HISTORIC PRESERVATION COMMISSION

Historic Area Work Fermit #545233—rear addition and alterations to house

MONTGOMERY COUNTY HISTORIC PRESERVATION COMMISSION STAFF REPORT

Proposal: Rear addition and alterations to house

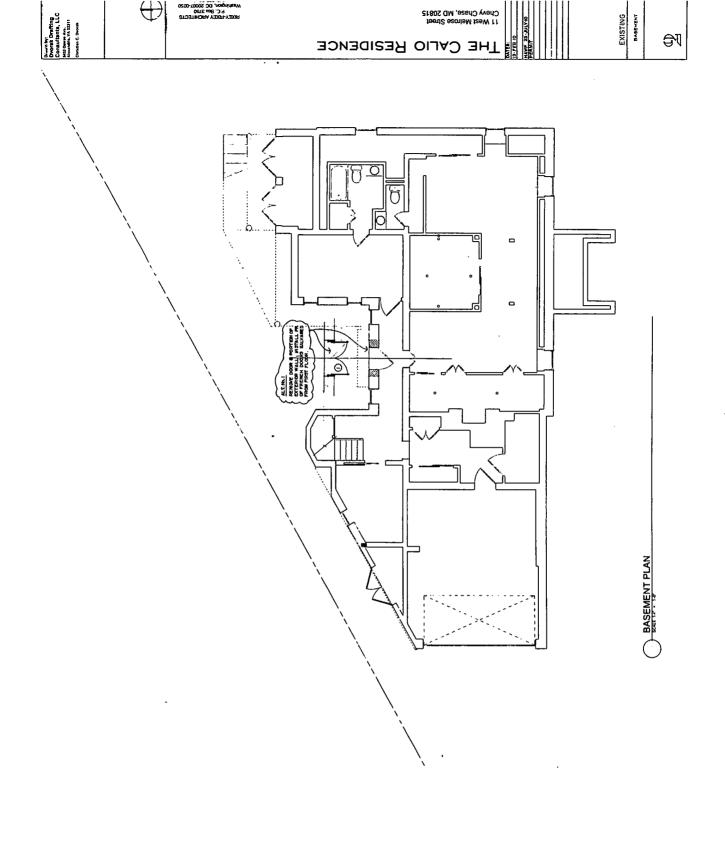
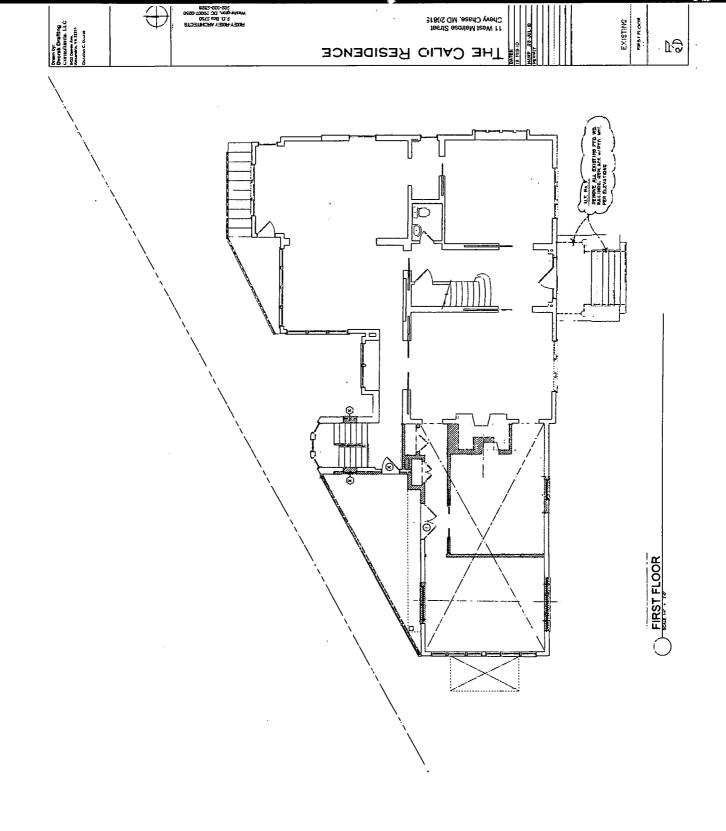
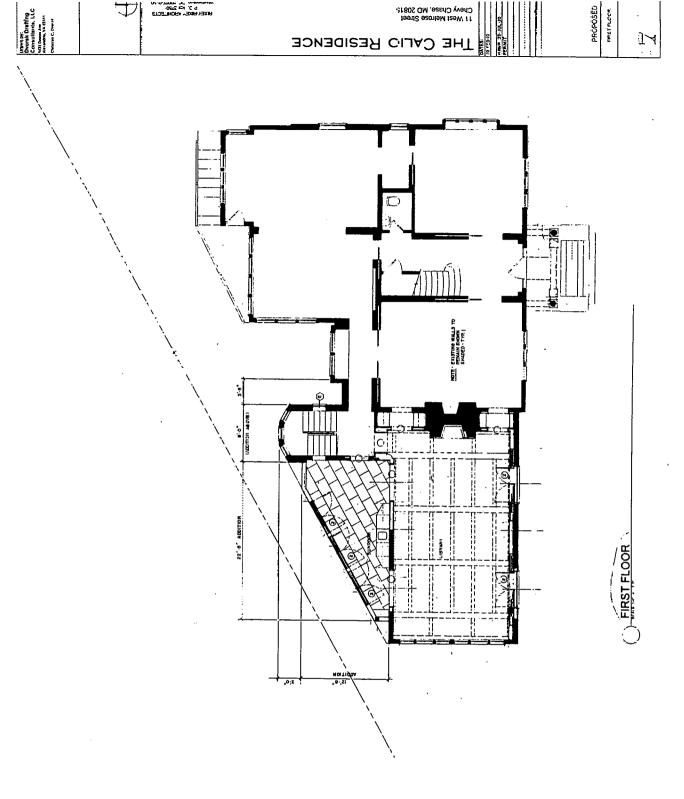
1. French doors are not approved on the front elevation; final window design to be reviewed and approved at the staff level.

The proposed changes to the front of the house receive a higher level of scrutiny because of their visibility, even though they are changes to the 1995 addition. The large side addition was built before Chevy Chase Village was a historic district designed and any future alterations to this block should be designed to ensure that the addition defers to the historic massing and doesn't add a feature that might compete with it. Staff supports the installation of additional windows on the front elevation of the addition if desired but recommends that the windows be similar in character to those of the main structure and simpler. The

proposed doors are too large and with the metal railings, they detract from the historic house which should be viewed as the prominent massing. Staff discussed this concern with the architect and the doors were simplified and the transoms were removed which improved the proposal. Staff recommends that the doors be changed to large windows which would still provide the desired light but would be more in keeping with the fenestration of the historic house and would allow the railings to be removed. Staff recommends approval of the proposed application with one condition.

- Regarding the French doors on the front elevation of the new wing/addition, the Owner, and I as well, are very reticent to change them to windows. While I understand the concern of having the addition overshadow the original house, the alterations were very carefully composed to develop a similar (though reduced) ratio of fenestration to blank façade. The existing addition is quite plain and drab, and in my opinion neither stands up to nor complements the existing house. The transoms are virtually the only interesting detail on the addition, and thus were used over the proposed new French doors to give the new wing some design coherency. If you feel they are too decorative, we would be willing to remove them and simply have French doors with rails and shutters. If the doors "to nowhere" are still considered inappropriate, we could certainly change the rails to small balconies (though this might complicate the shutter detail).
